# Attachment-9 Department and Agency Comments

Date	March 12, 2020
To	<b>Katie Nasswetter, Senior Development Planner</b>
From	David de Groot, Senior Urban Designer
Service Area	Infrastructure, Development and Enterprise Services
Department	Planning Services
Subject	<b>70 Fountain Street: Official Plan and Zoning By-law Amendment Application – Urban Design Comments OZS19-015</b>

Date	March 13, 2020
To	<b>Katie Nasswetter</b>
From	Stephen Robinson
Service Area	Infrastructure, Development and Enterprise Services
Department	Planning Services
<b>Subject</b>	<b>70 Fountain St/75 Farquhar St: Official Plan and Zoning Bylaw Amendment Application – Heritage Planning Comments</b>

**TO:** Katie Nasswetter, Senior Development Planner  
**FROM:** Shopan Daniel, Engineering Technologist III  
**DEPARTMENT:** Engineering and Transportation Services  
**DATE:** March 3, 2020  
**SUBJECT:** 70 Fountain Street – Zoning By-law/Official Plan Amendment – OZS19-015

Figure 24 - Heritage Character Areas

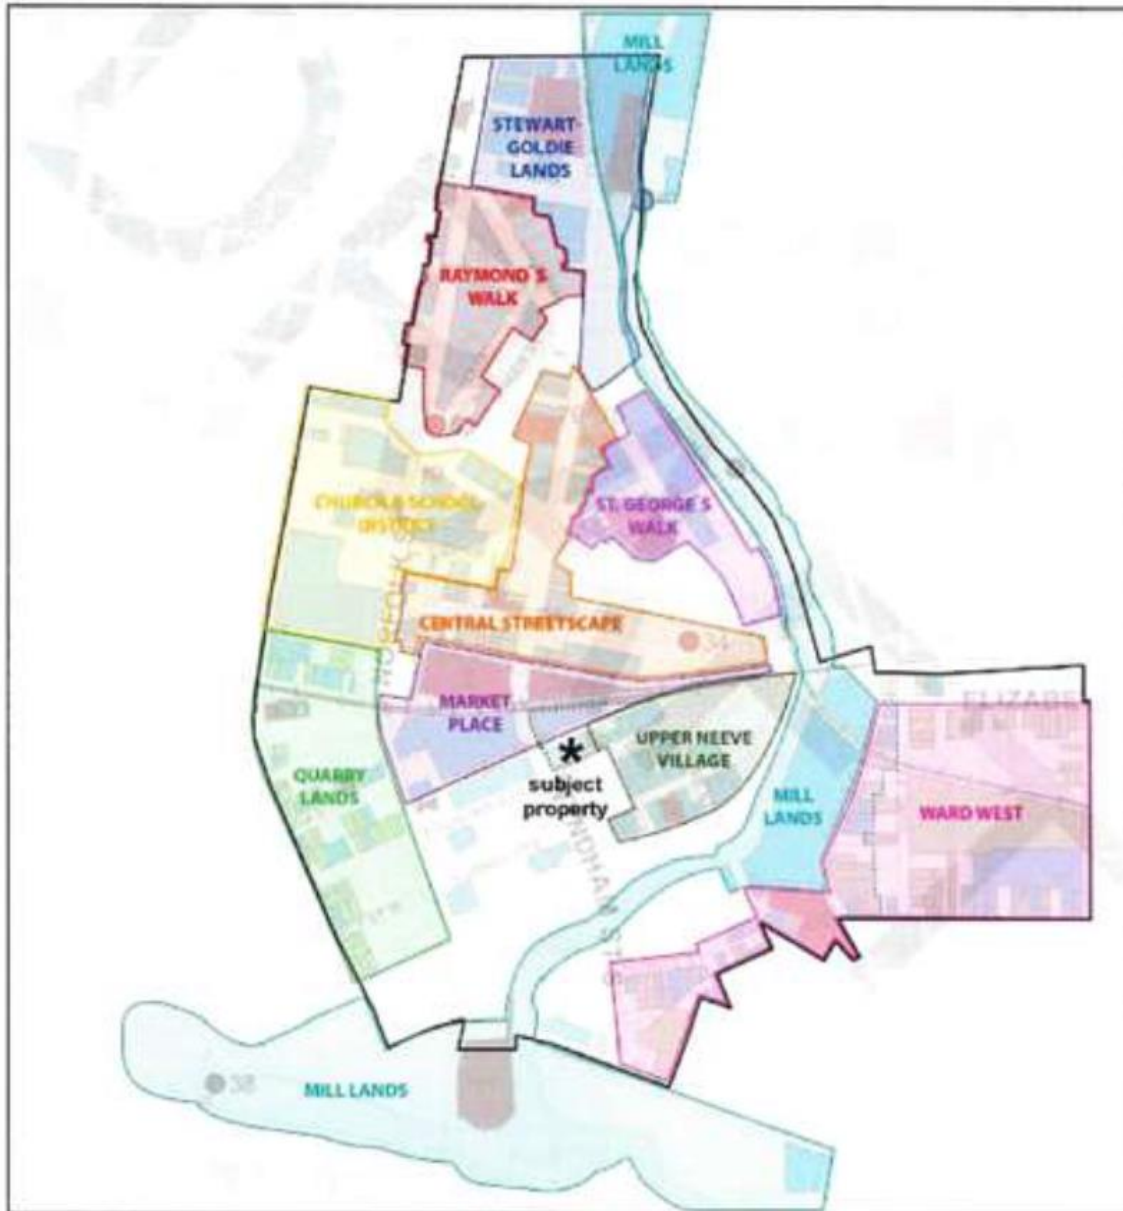
Attachment 5 (Figure 7 in the CHRIA by CHC Limited, November 2019) presents the ten heritage character areas identified in the downtown Built Form Standards. The author describes the neighbourhood south of the railway tracks as the "Upper Neeve Village" heritage character area identified by the Heritage Character Area Survey. It is important to point out that the character areas identified in the Downtown Streetscape Manual and Built Form Standards have un-delineated boundaries to allow for a degree of interpretation and that the hard line of the Market Place heritage character area can easily include the buildings that front on Farquhar Street. While it is true that the Upper Neeve Village is adjacent to the subject property, what CHC does not point out is that the "Market Place" heritage character area includes both the north and south sides of the railway tracks and that the subject property plays an important anchor role as a corner property at Wyndham and Farquhar Streets and is a major contributor in the delineation of the southern boundary of the Market Place (or Market Ground) heritage character area.

Figure 25 - Detail from Candidate Cultural Heritage Landscapes in Guelph (from page B-15 of draft Cultural Heritage Action Plan, November, 2019)

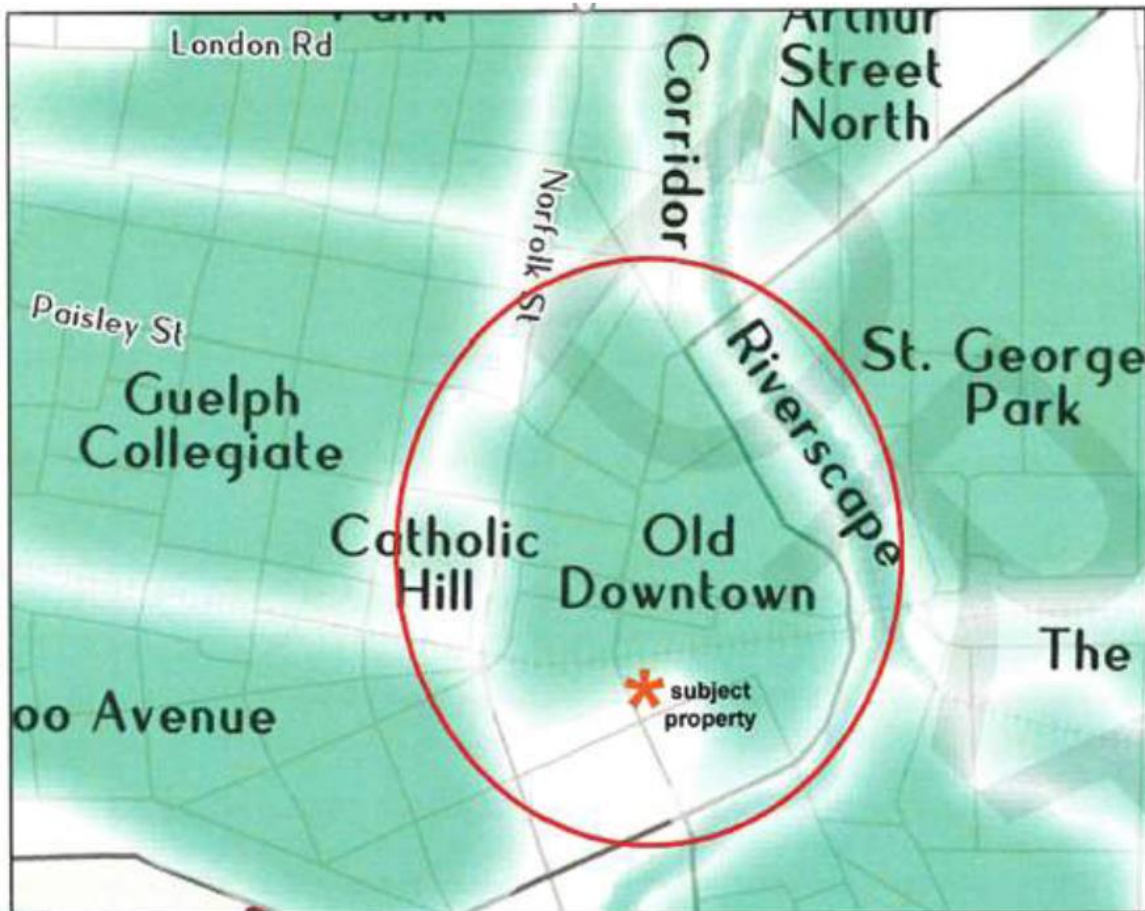
Figure 25 in Attachment 6 (Figure 62 in the CHRIA by CHC, November 2019) presents the "Old Downtown" candidate cultural heritage landscape (CHL) area identified by the City's current draft Cultural Heritage Action Plan. The candidate CHL boundaries are also in a preliminary form and hard line boundaries would only be confirmed after the candidate CHL area has undergone formal study (e.g. as a potential heritage conservation district). The Old Downtown CHL area includes several significant component areas, such as the "Upper Neeve Village" area and the Market Ground.
